MONTICELLO NUCLEAR GENERATING PLANT
Docket No. 263 License No. DPR-22

Off-Site Shipment of Spent Fuel

RESPONSE TO NRC INFORMAL QUESTIONS
DISCUSSED DURING MEETING WITH REGULATORY
STAFF ON APRIL 9, 1976

FIGURE A-2
SECTIONAL DRAWING OF NFS-4
FUEL SHIPPING CASK

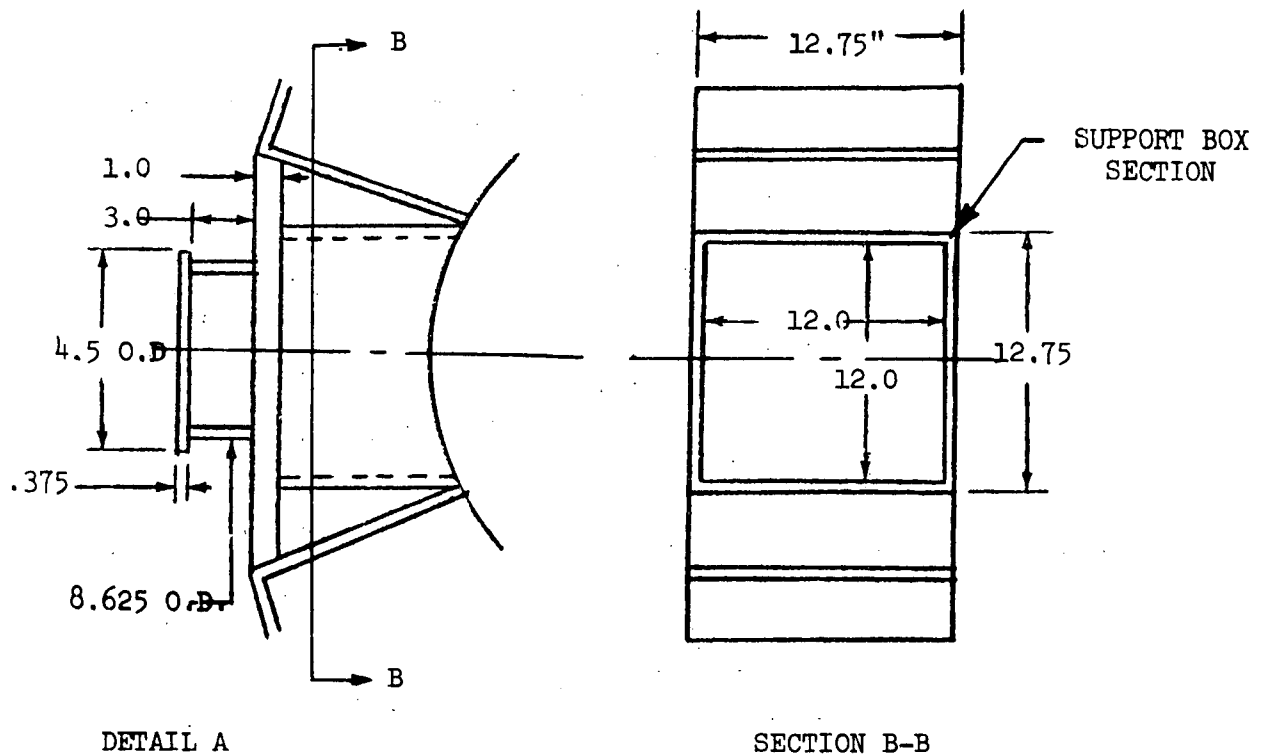
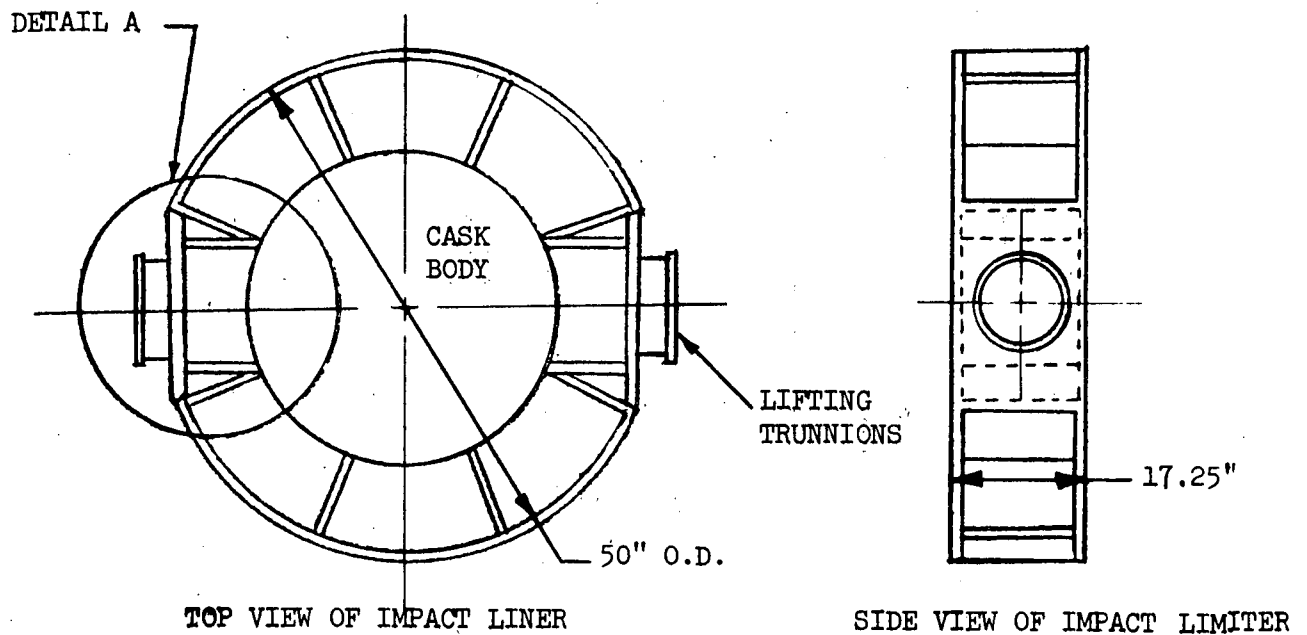
A review of the Safety Analysis Report for the NFS-4 Shipping Cask (Reference 5 of your January 13, 1976 report) and your report dated January 13, 1976 does not contain sufficient information on the handling yoke as it applies to its onsite use, to enable us to complete our review. Provide the following additional information:

- a. Provide legible individual drawings of the shipping cask showing the lifting trunnions, the handling yoke and the twin sister hook and shackle hole.
- b. Describe and discuss the load carrying capabilities of the shipping cask lifting trunnions, the handling yoke and the point of attachment of the handling yoke to the main hoist twin sister hook.
- c. Modify Table 4-1 by adding the factors of safety for the items identified in (b) above.
- d. Describe and discuss what modifications or means are possible for devising redundant load paths from the shipping cask to the main hoist hook.

- a. Figure A-2, attached, gives a sectional drawing of the NFS-4 cask as described with lifting trunnions included. Figure A-3

The NFS-4 shipping cask is shown in Figure A-2 as submitted with the response to Question 10. The impact limiter device attached to the cask bottom head surrounds the cask body and consists of a 50 inch diameter by 17.25 inch high stainless steel ring with 3/8 inch stainless steel gusset plates filled with balsa wood for impact absorption. The impact limiter is encased in a 1/4 inch shell of stainless steel with a 1/2 inch bottom plate and a 1/2 inch shock tube for impact resistance. This design ensures maintenance of impact limiter integrity during routine handling.

FIGURE 3-7

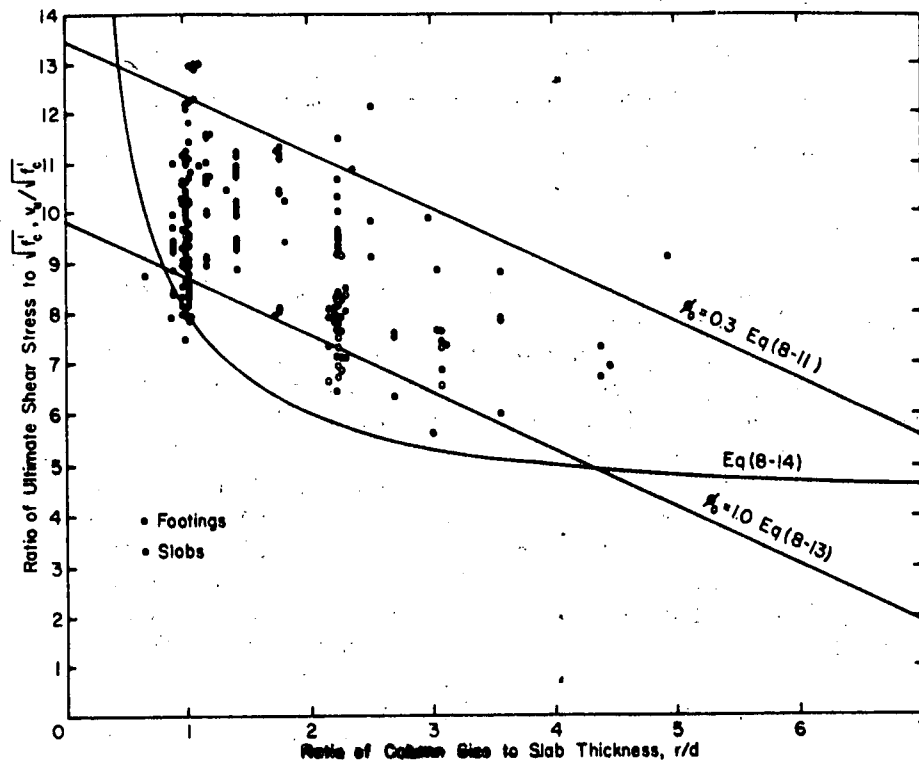
On page 3-8 it is indicated that the force acting on the structure is checked for punching shear and end shear on the slab and beam. Indicate what limits are used to arrive at the acceptance criteria.

Comparison of this equation with an expression developed by Moe from test data (see Reference 7) is reported in Reference 6 and reproduced in attached Figure 3-7. This plot shows the validity of Equation 8-14.
